7850000 INTELLIGENT TRANSPORTATION SYSTEMS – INFRASTRUCTURE
COMMENTS FROM INTERNAL/INDUSTRY REVIEW

In accordance with Specification Development Procedures, we are sending you a copy of a proposed specification change.

This change was proposed by Gene Glotzbach to update technical requirements for Surge Protective Devices.

Slide A2 - MOVs, Safety & Affect on I-n

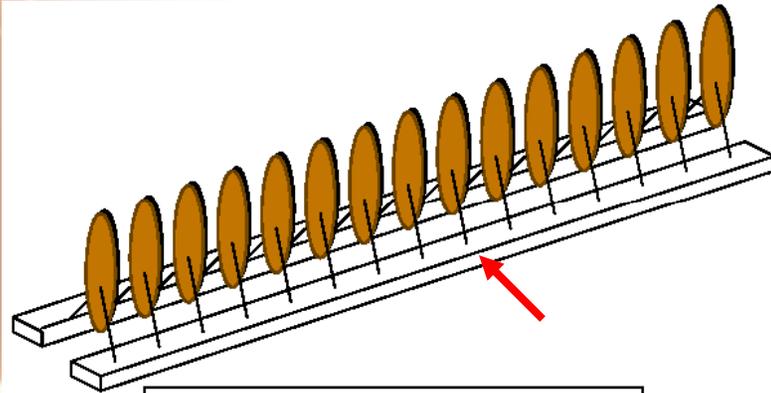
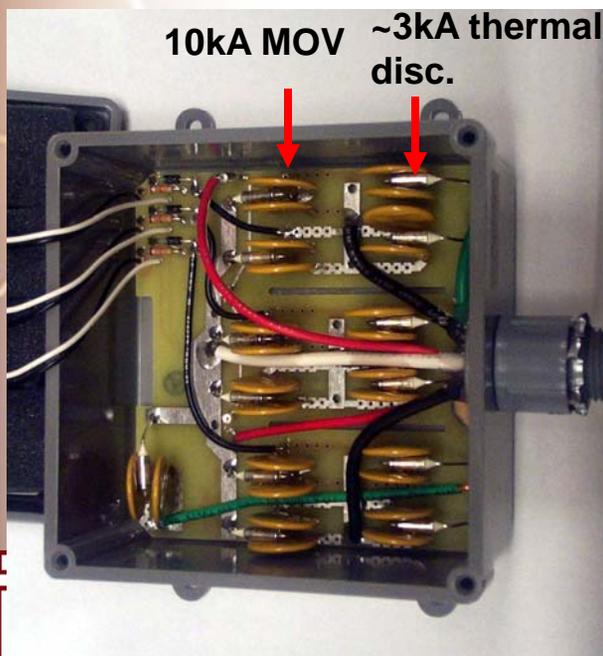
Figure 1 – Paralleled MOVs provide a theoretical maximum surge current rating.

These are 10kA MOVs. In theory, 15 10kA MOVs equals 150kA.

Problem is that small MOVs do Not share equally. One will dominate, one will slack, others will be in between.

Another problem is that safety disconnectors tend to reduce the MOV's surge current capability

Actual surge current capacity is usually the rating & effectiveness of safety disconnectors – not capacity of MOVs

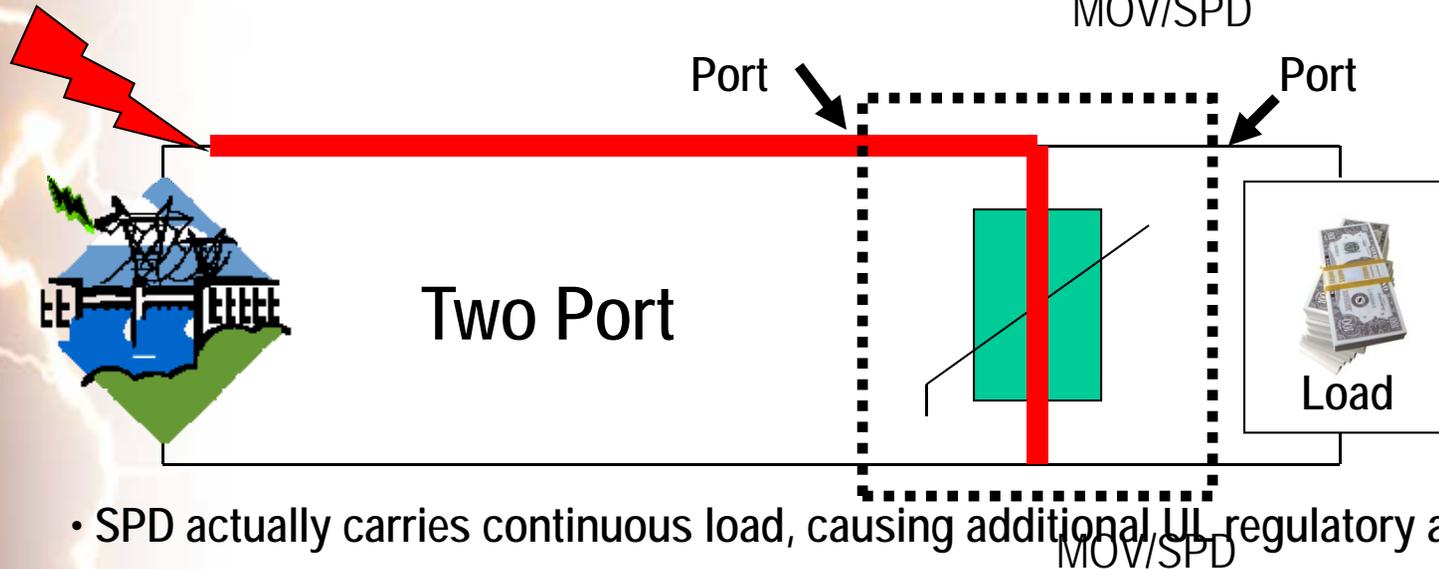
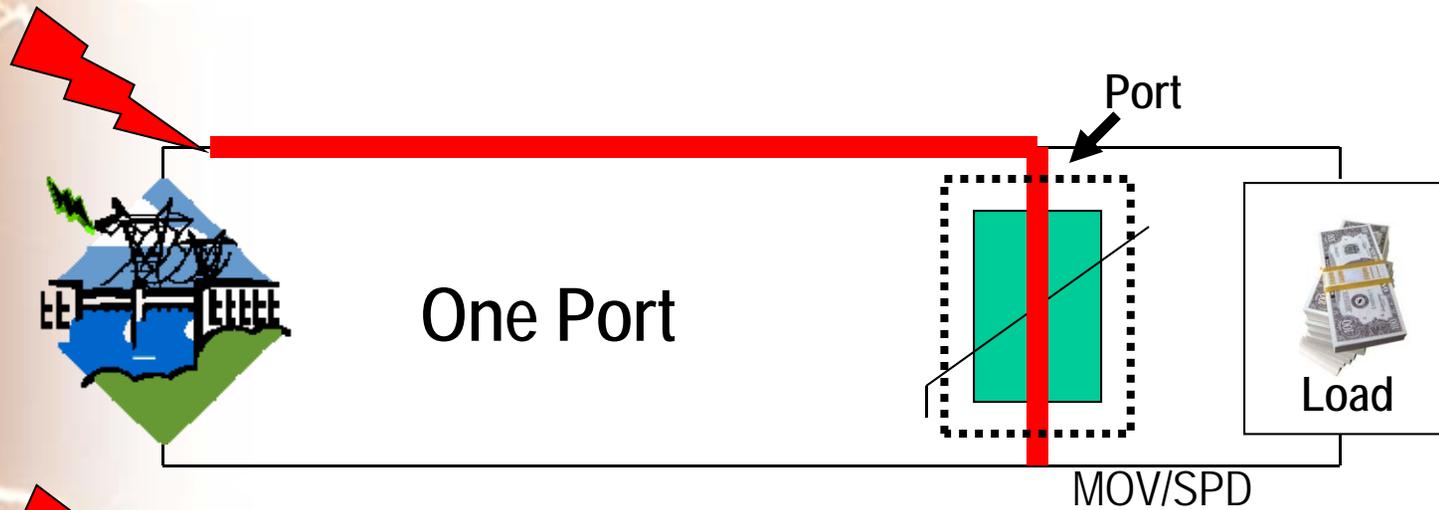
20A breaker – passes about 10-15kA surge current (once)

10kA MOV (mustard)

Thermal disconnect (white) Passes about 3kA – limits surge current

'Small' 20A circuit breaker required as overcurrent protection – also limits surge current

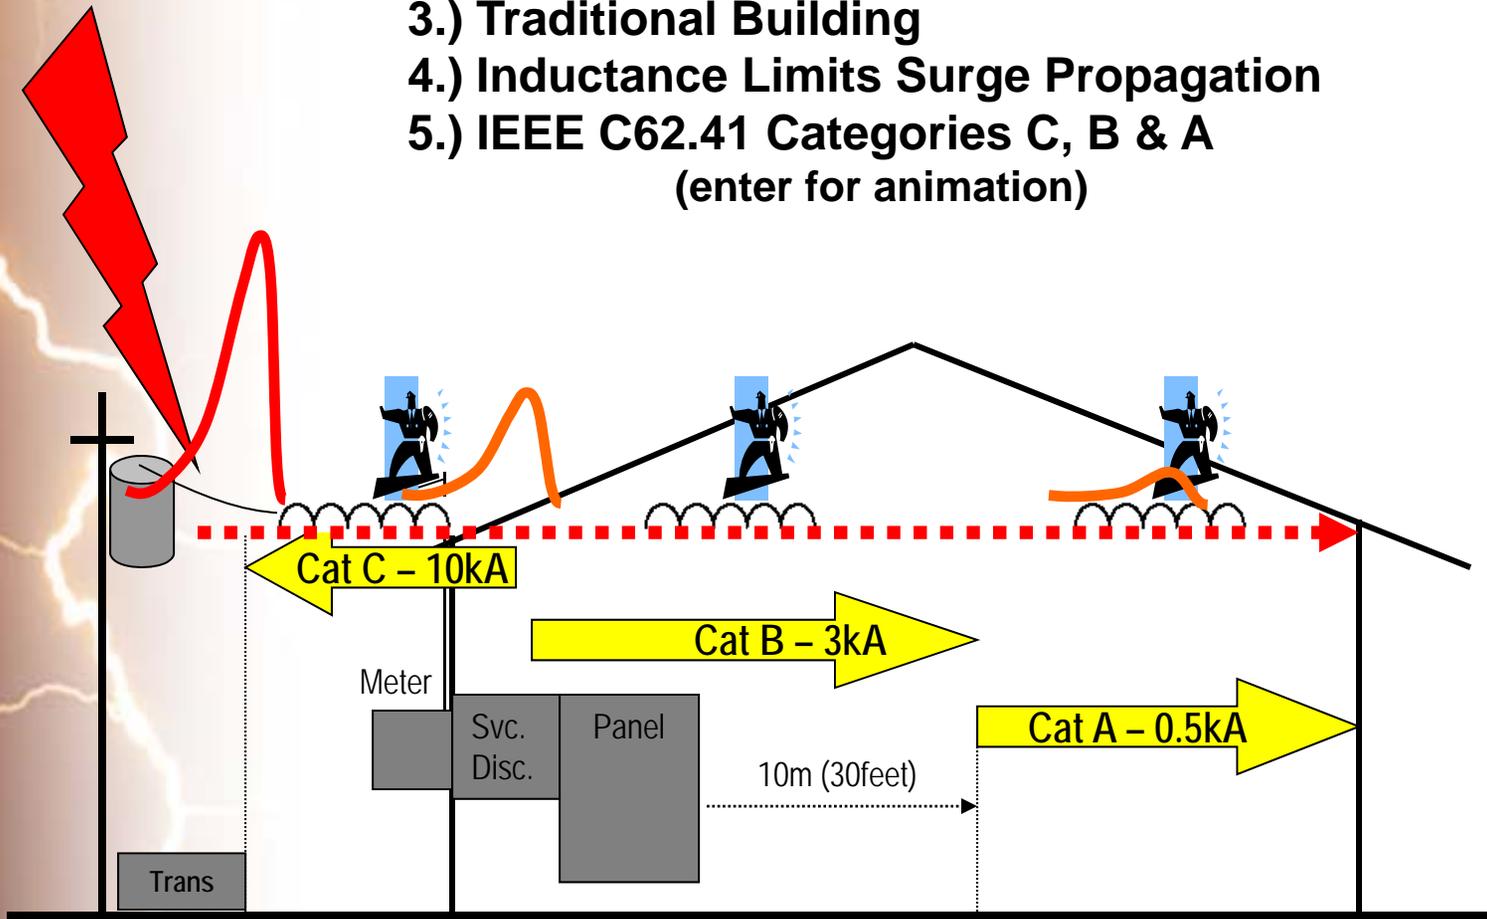
2.) Note that there are two (2) Cat A waveshapes

- Combo Wave**
- Ringwave**

3.) The electrical system's Ground Reference is at the Service Entrance, not downstream. Recommend L-G protection (can make solid argument for N-G protection too)

A4-2 Does This Transfer to FDOT Application??

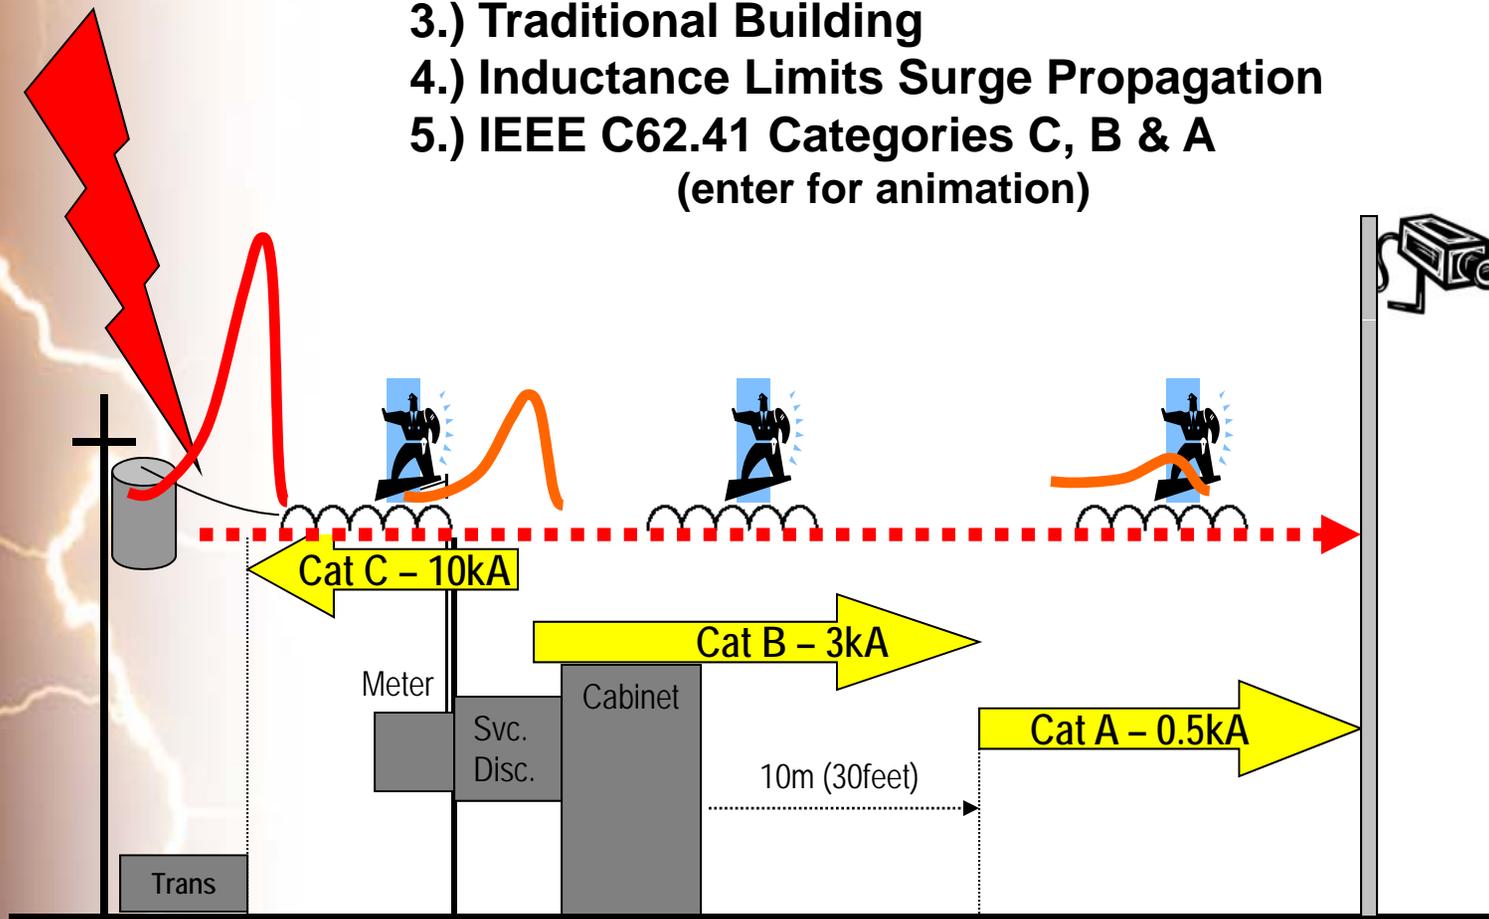
- 1.) Surge Is From Service Entrance
- 2.) Surge Hits Line
- 3.) Traditional Building
- 4.) Inductance Limits Surge Propagation
- 5.) IEEE C62.41 Categories C, B & A
(enter for animation)

Surge Near Load:

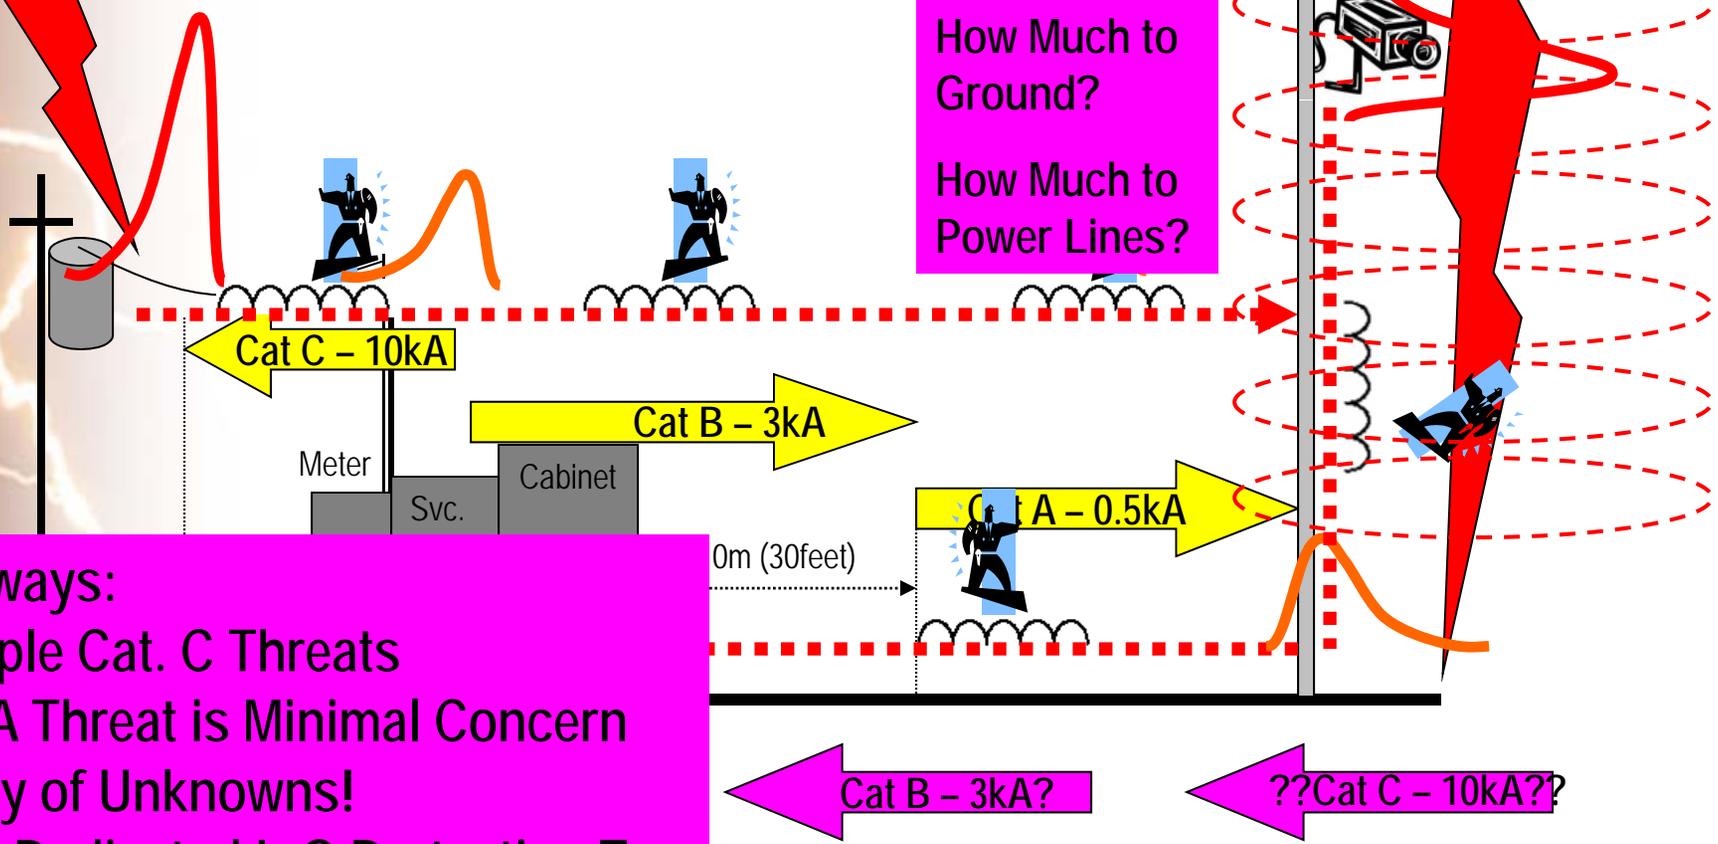
- 1.) Surge Hits Ground/Grounded Equip.
- 2.) Elevated NON-Traditional Structure
- 3.) Inductance Limits Propagation
- 4.) IEEE C62.41 Categories C, B & A?
(enter for animation 2)
